**Nevada
Nuclear Waste
Storage Investigations Project**

**MONITORING AND MITIGATION
PLAN
FOR SITE CHARACTERIZATION**

REVISION 1

6.2.3 Modification due to Other Factors	6-2
REFERENCES	R-1
APPENDIX A - Locations, by coordinates, of existing sites and planned site characterization activities at and near Yucca Mountain	A-1
APPENDIX B - Comment Analysis Document for December 1986 Environmental Monitoring and Mitigation Plan	B-1
MAPS	M-1

Figure 3-4. Conceptual illustration of the exploratory shaft facility.

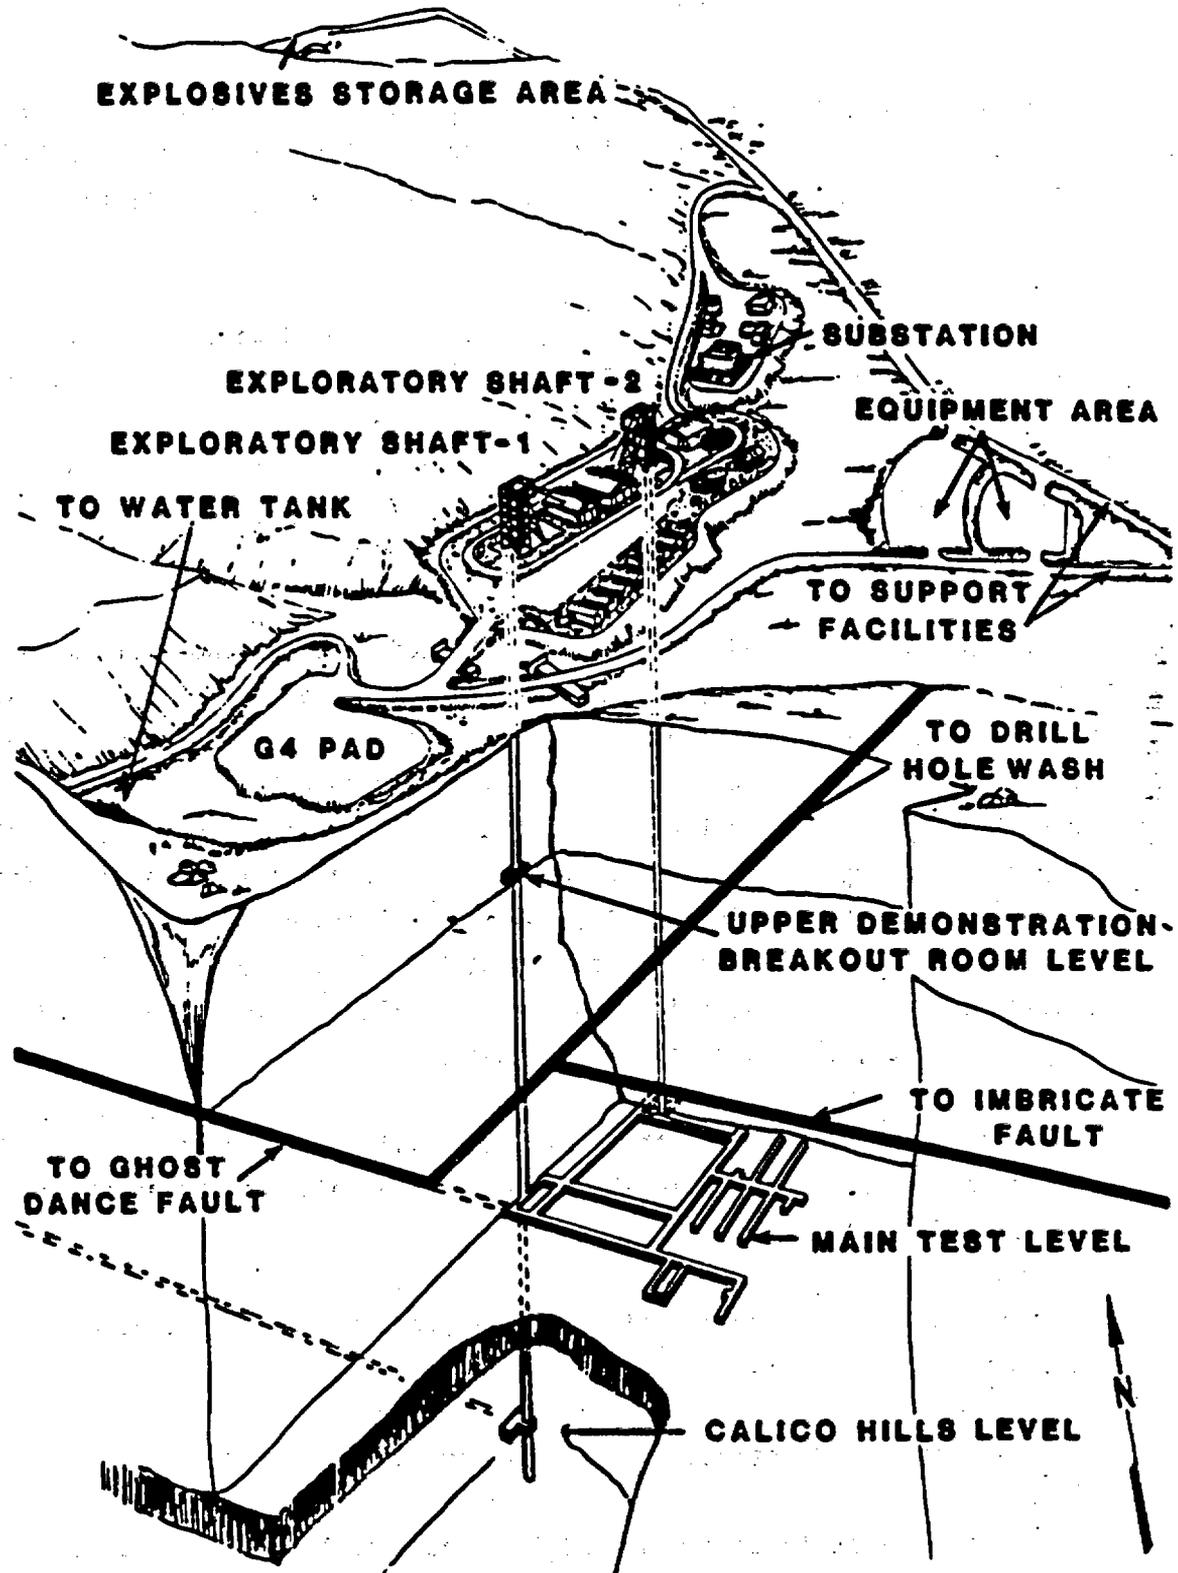
EMMP Section 3.2.4 and Figure 3-4 describe new utility construction at the Yucca Mountain site for water supply distribution, sewage disposal, and electrical transmission. There apparently has been no evaluation of the consequences of these operations to such issues as allocated water rights, leaching and ground-water contamination from the septic field, and construction of new electrical transmission facilities. The State of Nevada does not agree that the existence of utilities at NTS implies that new facilities at the Yucca Mountain site will have no environmental impact. At a minimum the design plans for the facilities to be constructed must be reviewed and DOE must demonstrate through its prior acquisition of appropriate permits and other regulatory approvals that the utilities at NTS were designed and are being operated in accordance with sound environmental protection practices and standards.
